Our Cultural Heart

Phase 2, Kirklees, Huddersfield

Design and Access Statement

Document No:	IR430300-CTA-ZZ-XX-RP-A-00017
Revision No:	P02
Date:	24.04.2026
Authored by:	AC
Checked by:	AN

Proposed Level 01 Layout

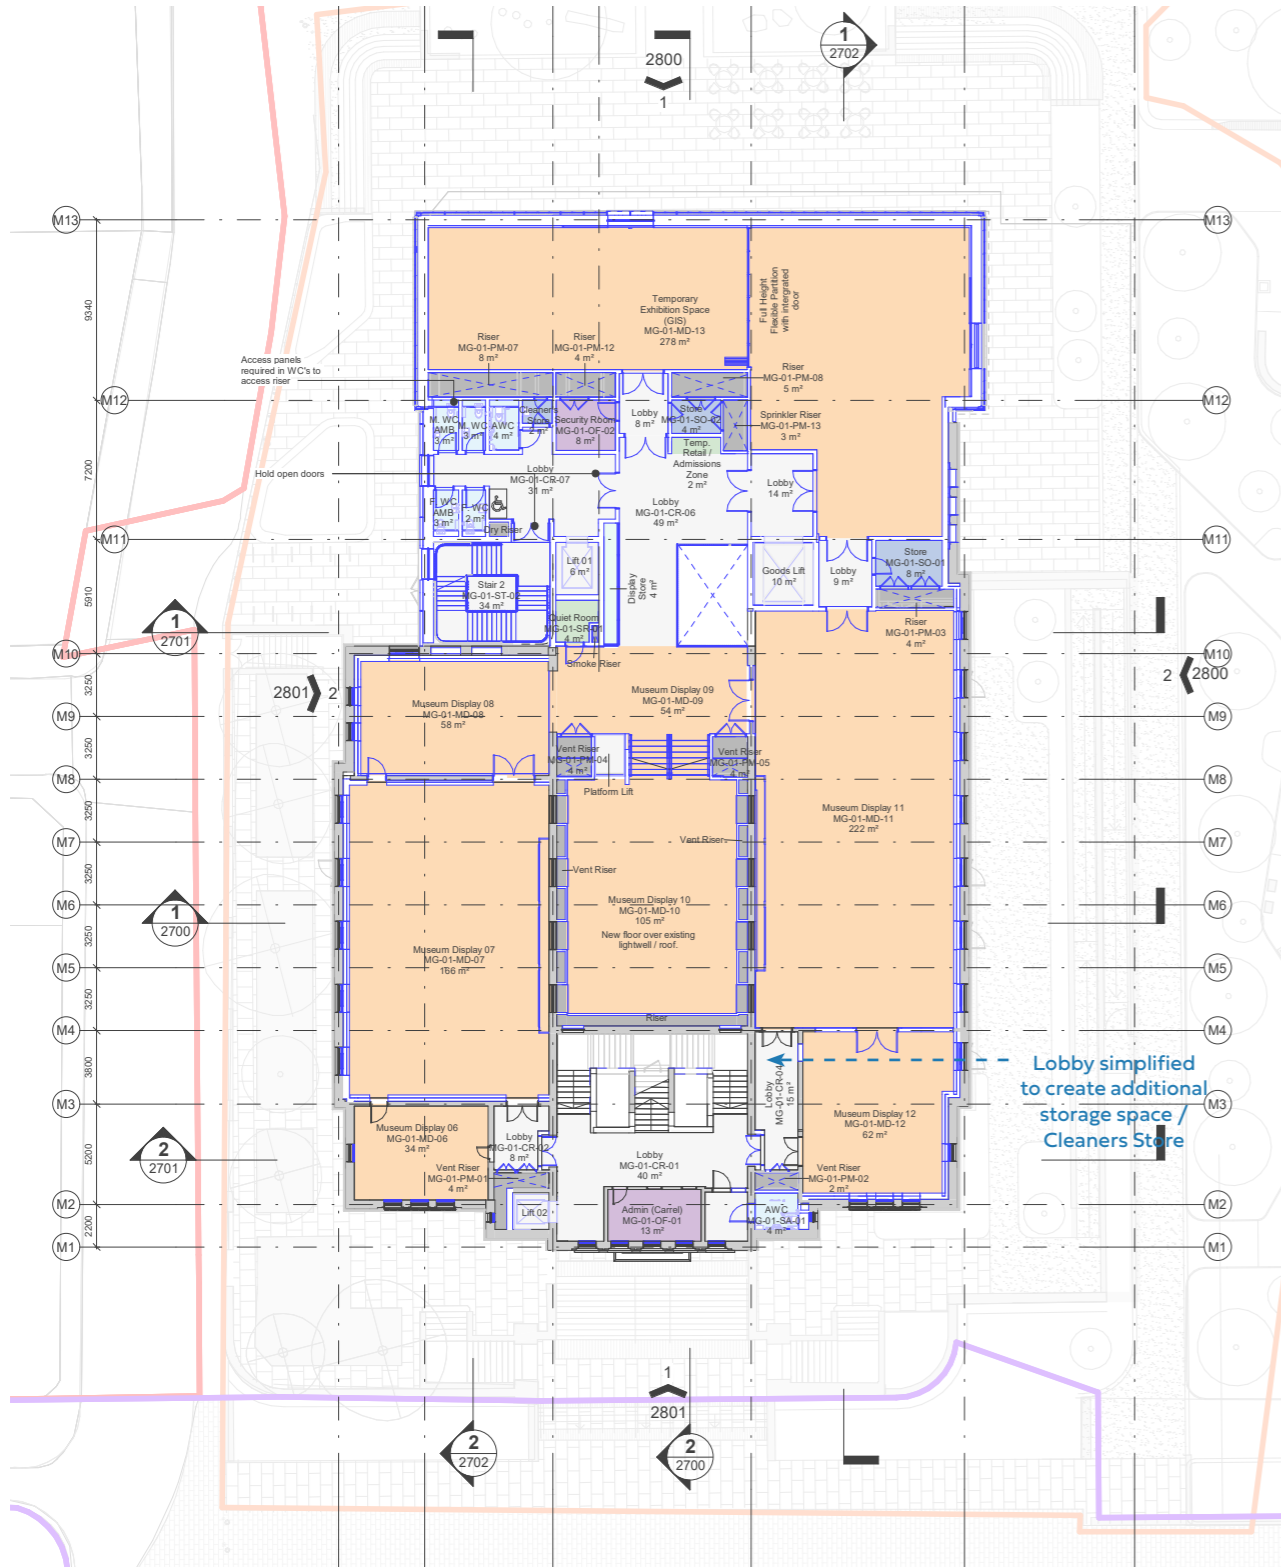
The visitor toilet provision has been revised in order to maximise display space whilst meeting the requirements of Approved Document T of the building regulations for toilet provision. A mix of male, female and gender neutral accessible wc cubicles are provided.

Step free means of escape from Display area 10 will be provided by a ramp located in Display area 11, which will be provided as part of the museum and gallery fit out. The ramp design will be developed to integrate with the display spaces and exhibits.

Proposed Level 02 Layout

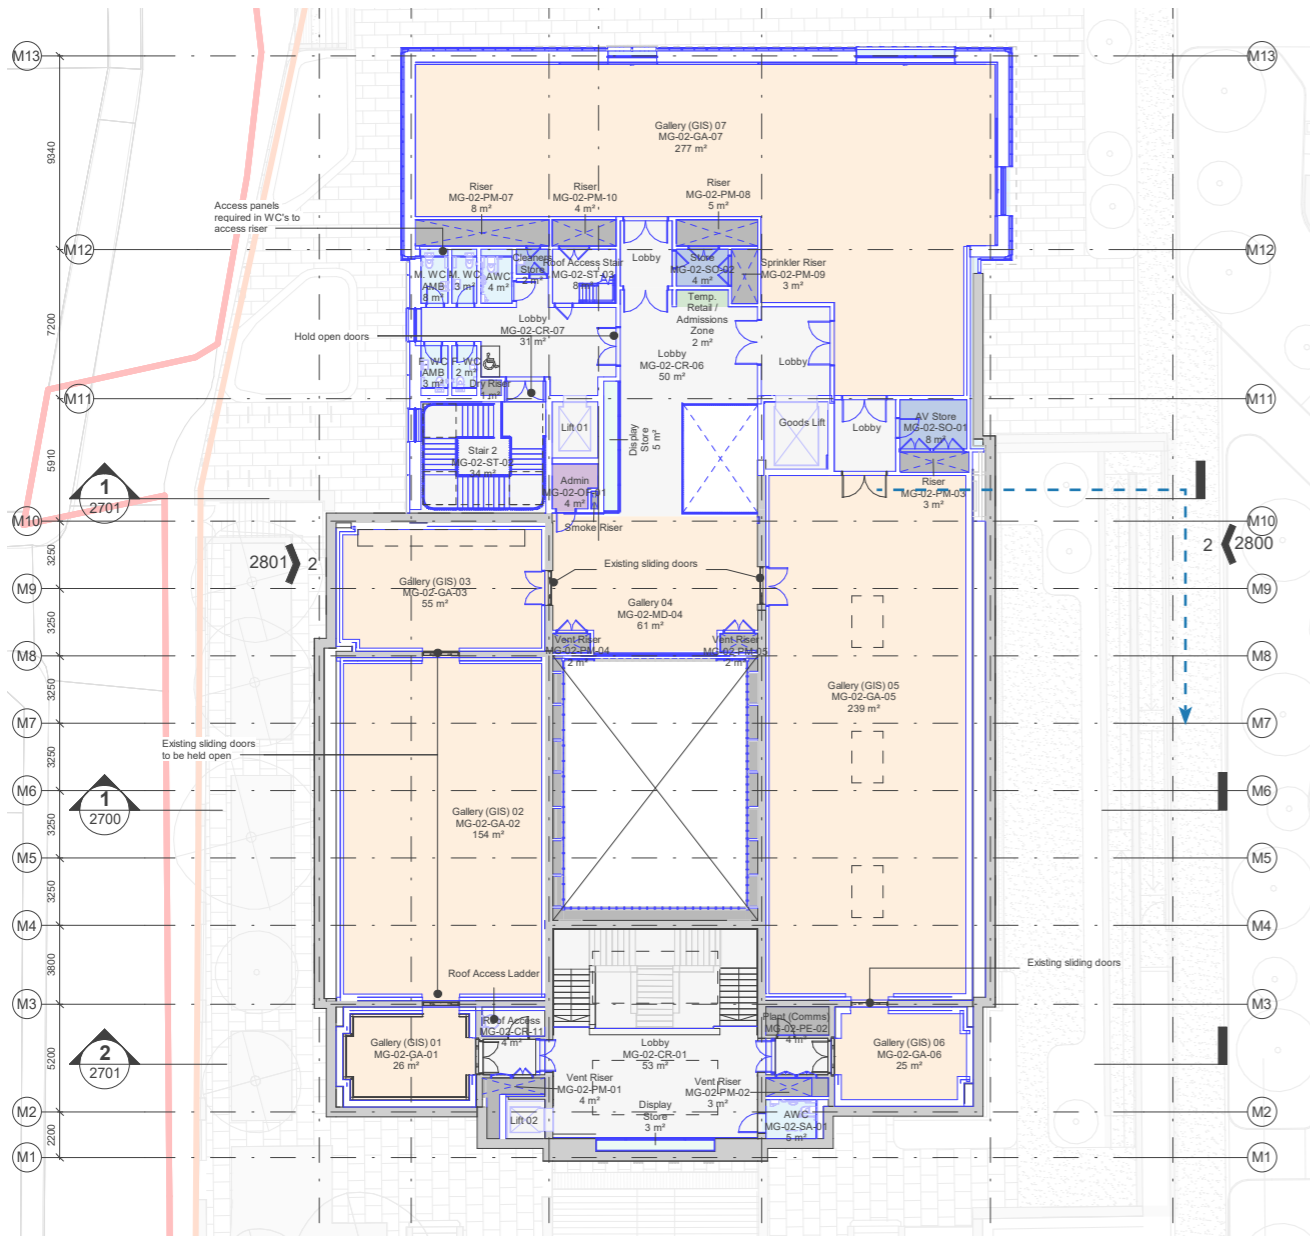
The picture store is relocated to Level 02 to improve the operational efficiency of the art gallery and improve the links between the storage and display spaces.

The toilet provision at this level is reduced to allow for an increase in gallery space, though accessible wc facilities are provided at this level also.

The design has been further developed to respond to the client brief, including the GIS requirements for the display areas.

Proposed Phase 2 Landscape Design

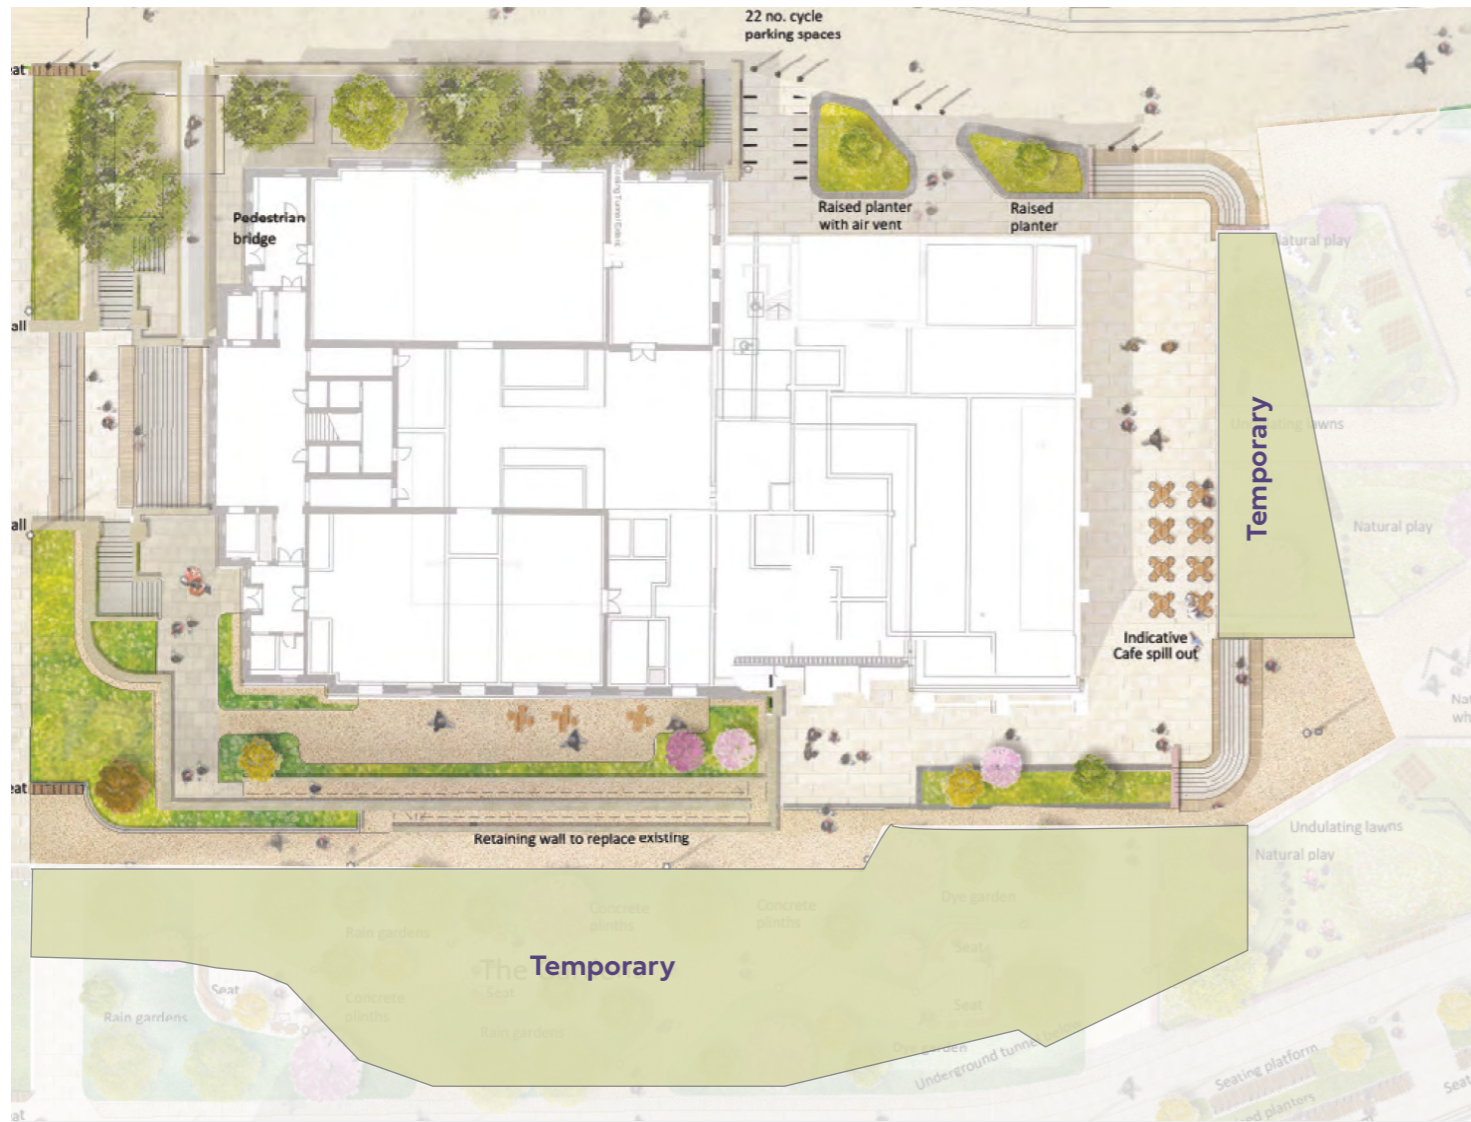
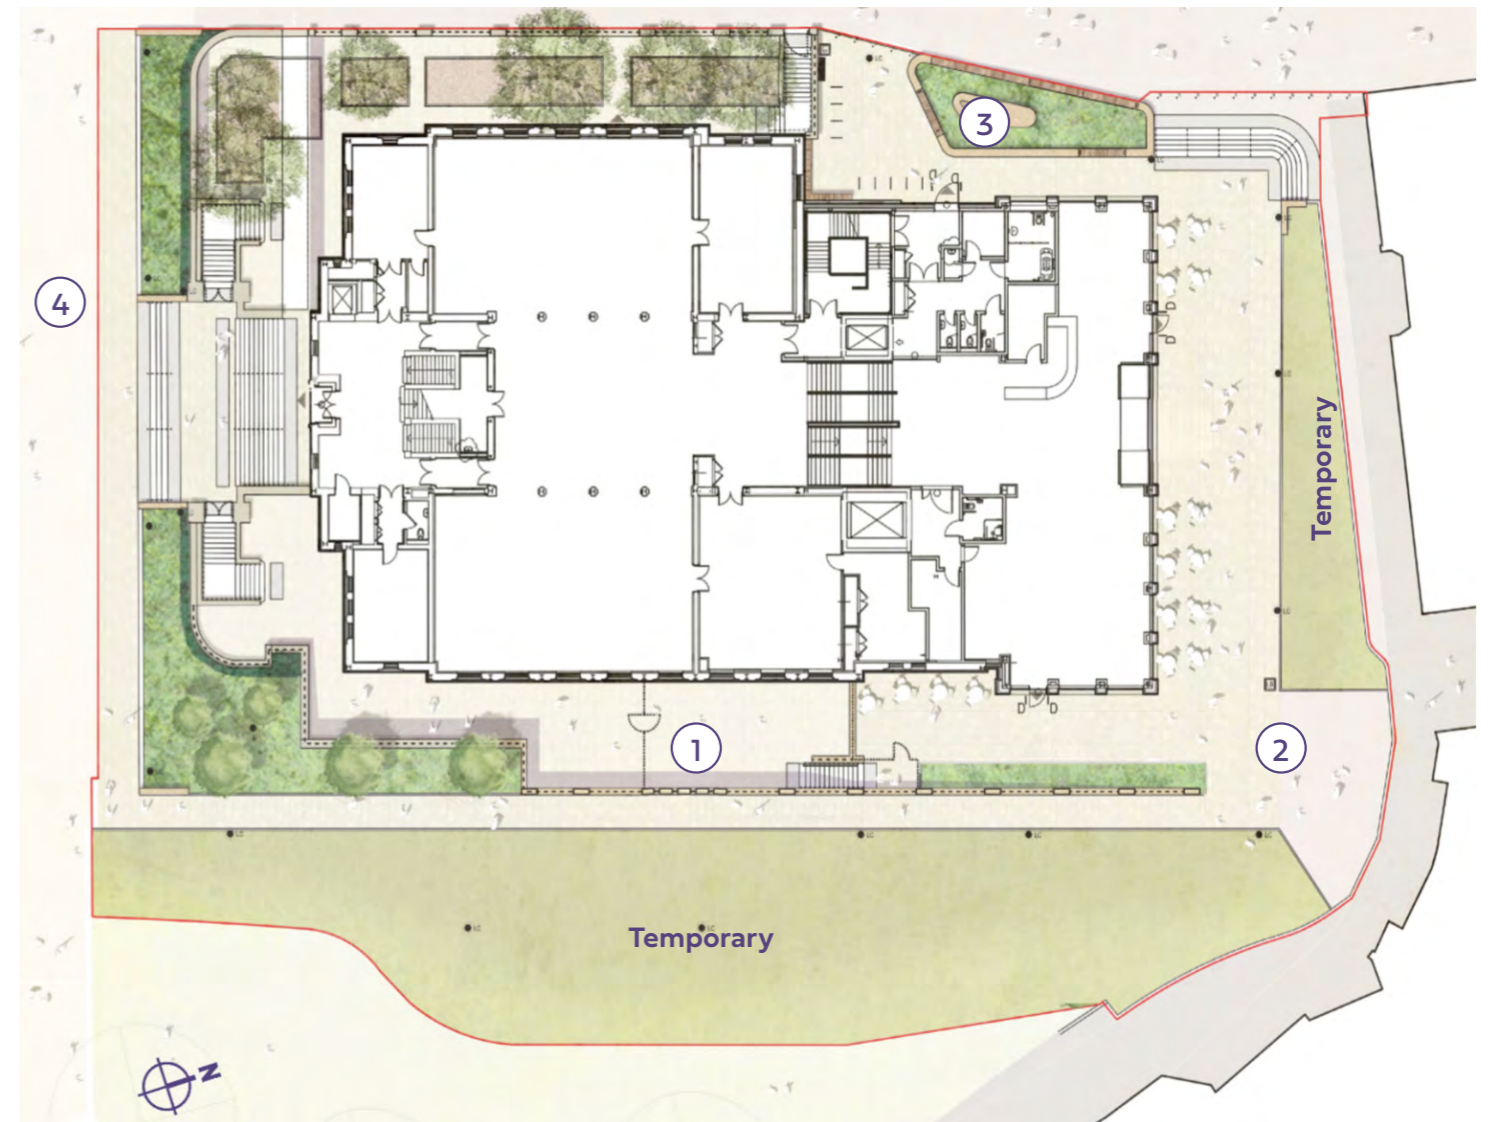
- ① The lower ground courtyard is now a private area for education use and also provides external back of house areas for staff access to cycle storage and workshops. Secure stepped access is provided from the upper level.
- ② Step free access is provided to the north east corner of the new extension, improving access to the building. New feature bench seating and planters incorporated into the upper terrace design.
- ③ Planter design has been developed to accommodate step free access from Victoria Lane and appropriate gradients to improve access.
- ④ Minor modifications to the Phase 2 boundary following detailed design coordination between Phase 1 and Phase 2 boundaries.
